STATE OF MICHIGAN
DEPARTMENT OF ENVIRONMENTAL QUALITY
LANSING

August 20, 2009

SUBJECT: G&H Landfill Superfund Site, Review of January – July 2008 Report

Charts 1 through 8

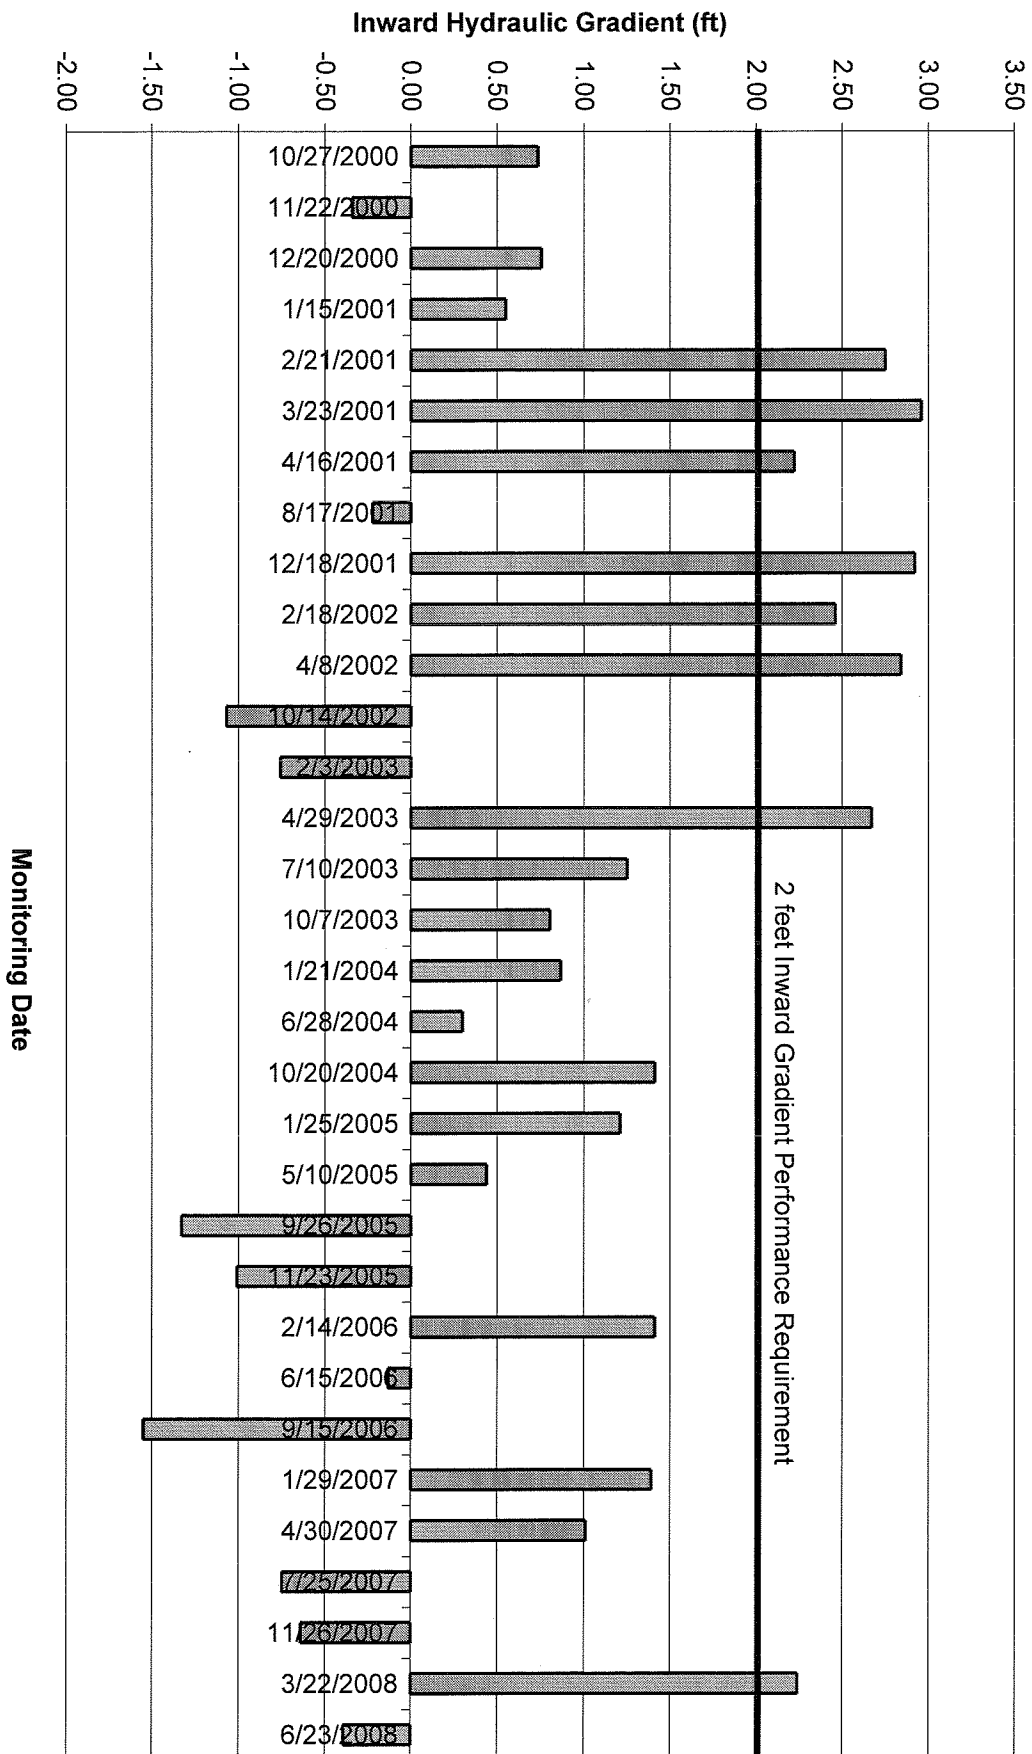
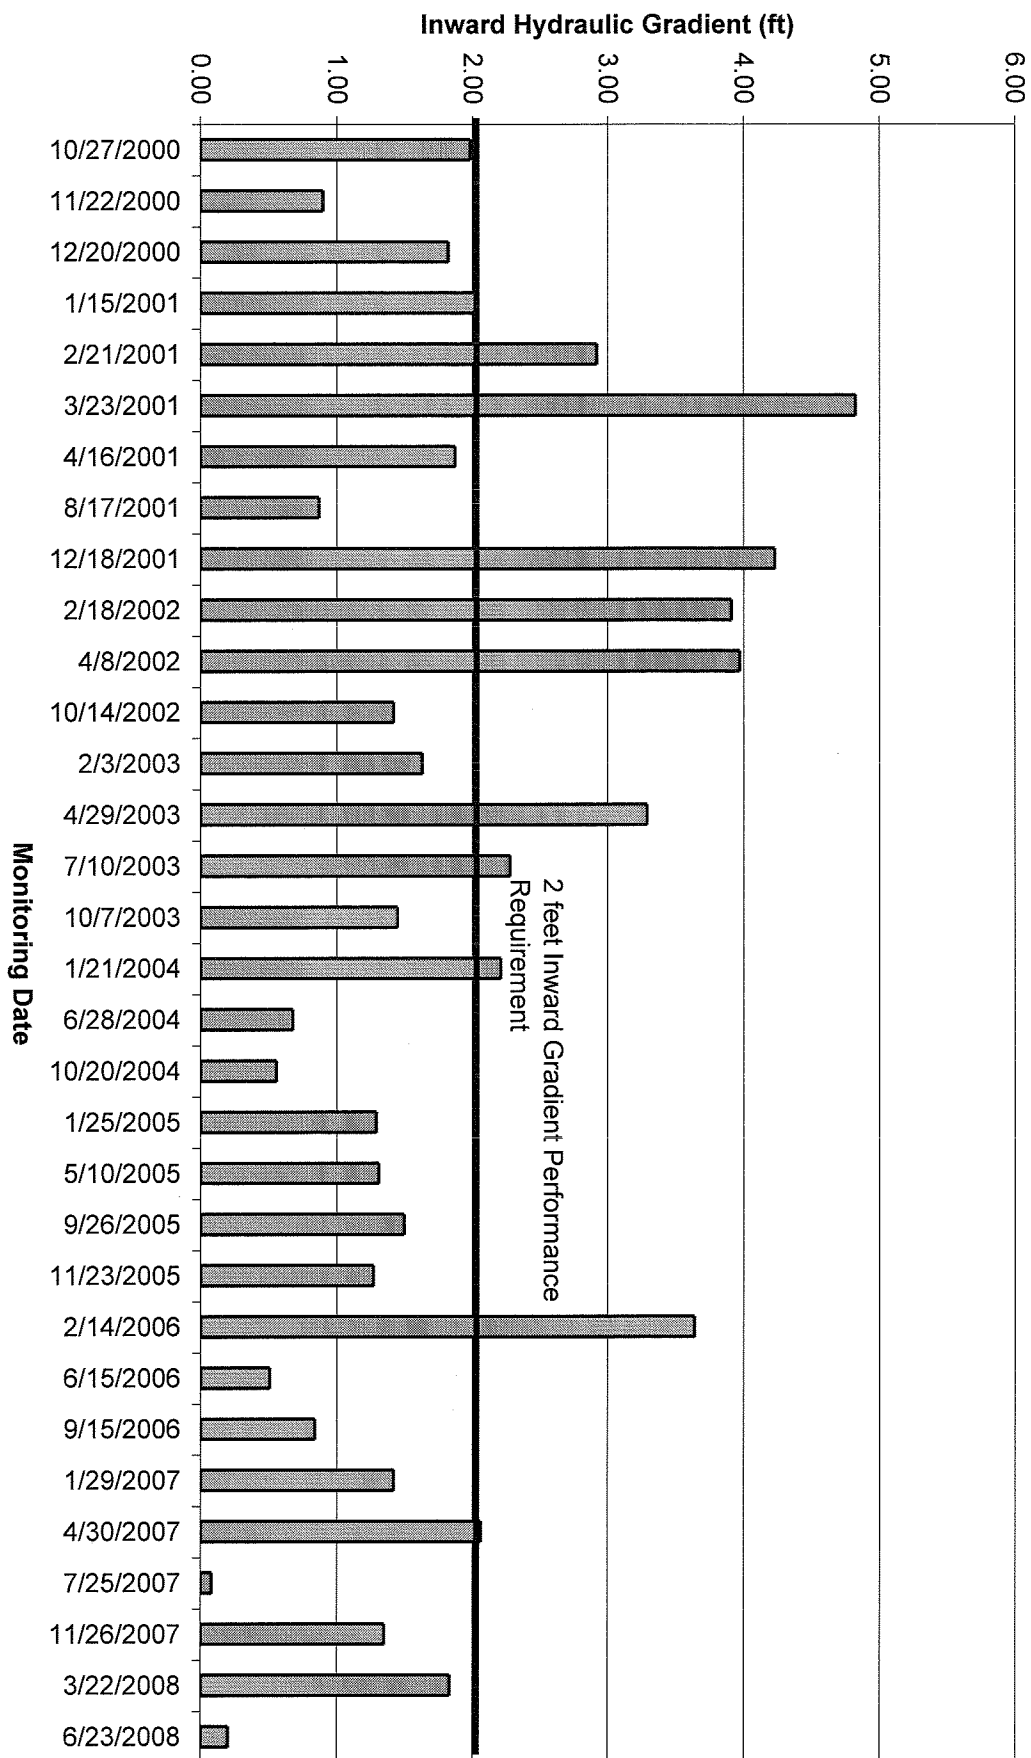
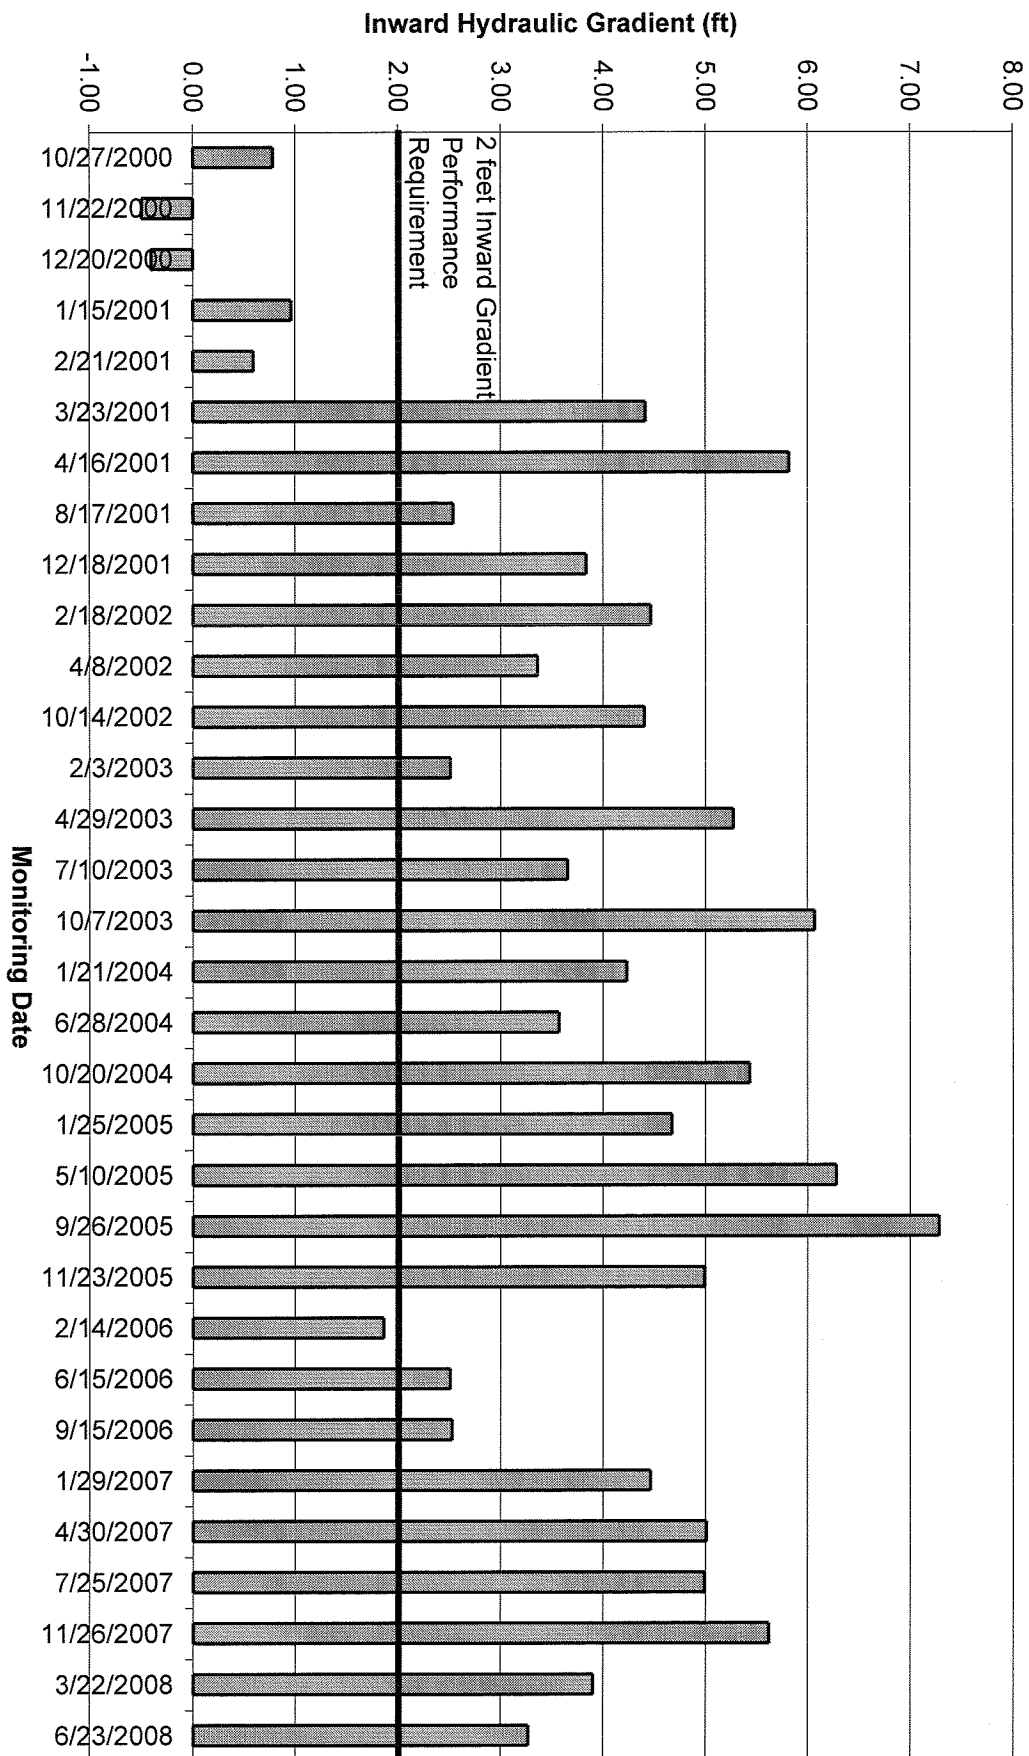
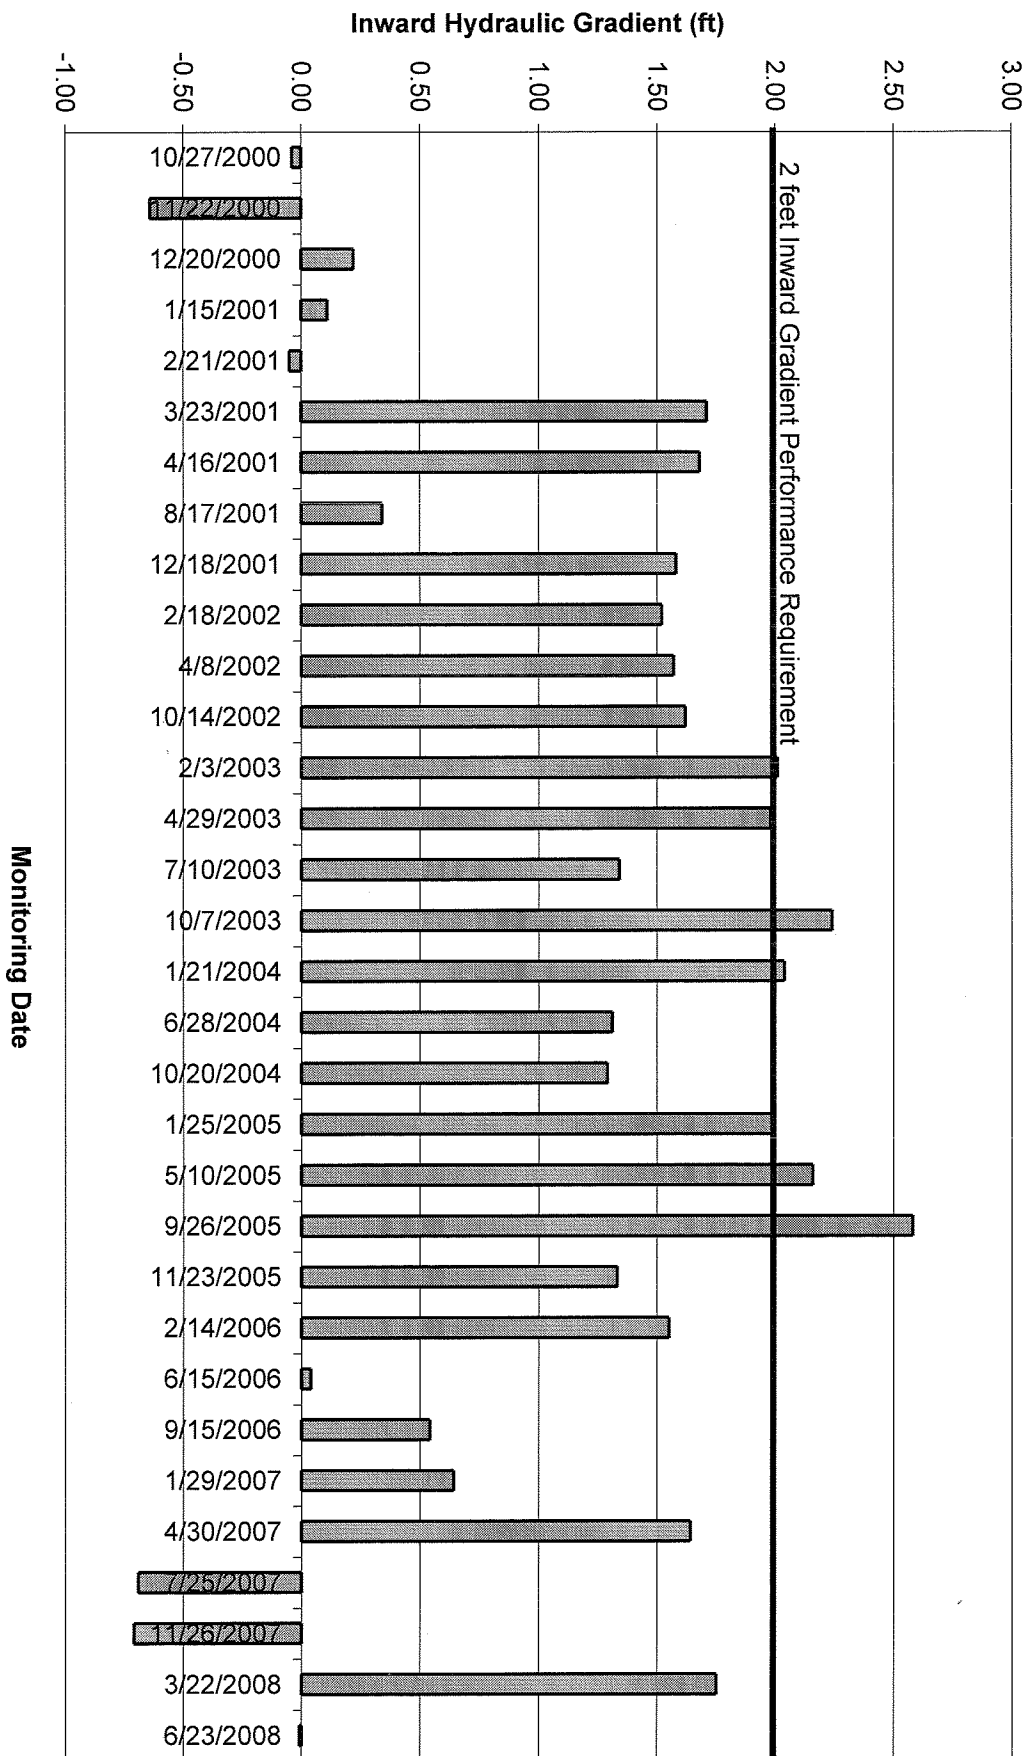
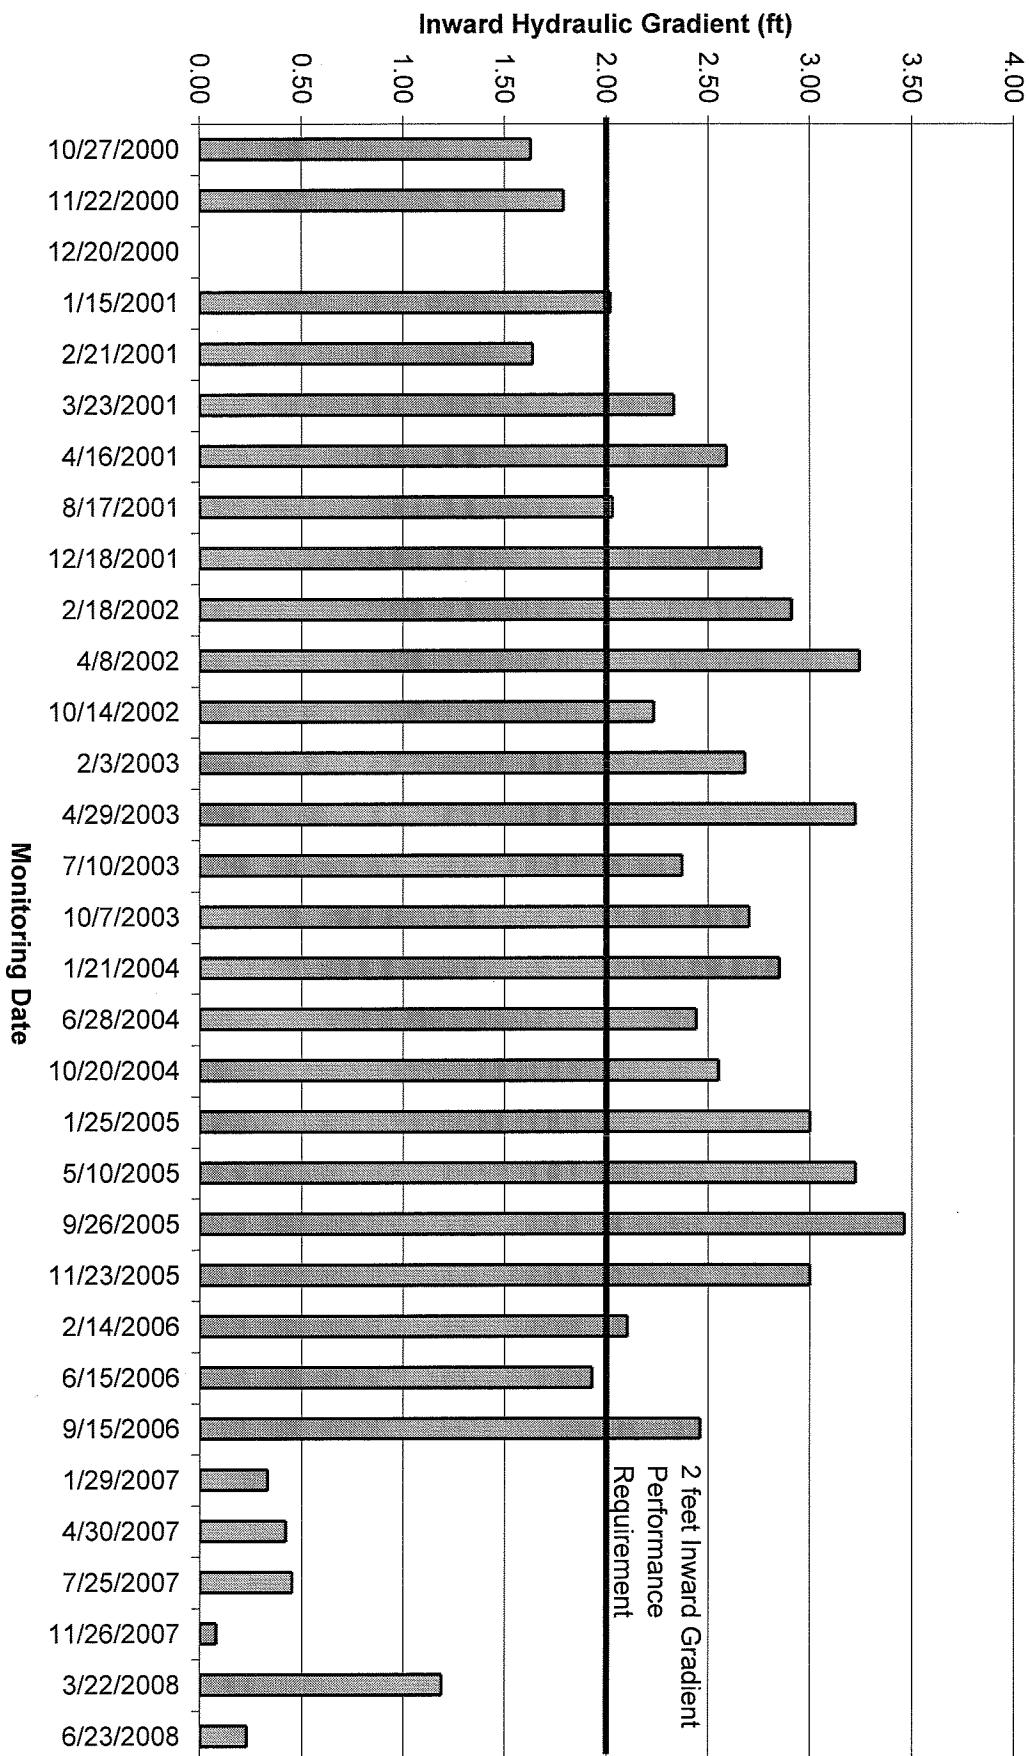
The inward gradient achieved across the slurry wall, during the past 8 years of operation, was evaluated by the MDEQ by comparing the inward gradient achieved (expressed in feet) over time at the internal/external monitoring well pairs along the slurry wall. Results of that evaluation are attached to this letter (Attachment A, Charts 1 - 8). The charts illustrate that the 2.0 feet inward gradient:

- Has been achieved and maintained at the GH-56/57 pair;
- Has been initially achieved and maintained, but has been lost in recent years at pairs GH-60/61, GH-80/81, and GH-82/83; and
- Has rarely been achieved at pairs GH-52/53, GH-54/55, GH-58/59, and GH-78/79.

Charts 1 through 8 also show that an outward gradient occurred frequently at pair GH-52/53 and occurred at pair GH-58/59 for most of 2007.

- Implement the approved corrective action plan to achieve hydraulic and physical containment of the source areas;
- Execute contingency plans to achieve the 2-feet inward gradient at the barrier wall and maintain water levels to allow the collection of NAPL from the Phase I and Phase II landfill cells as required in the SOW;
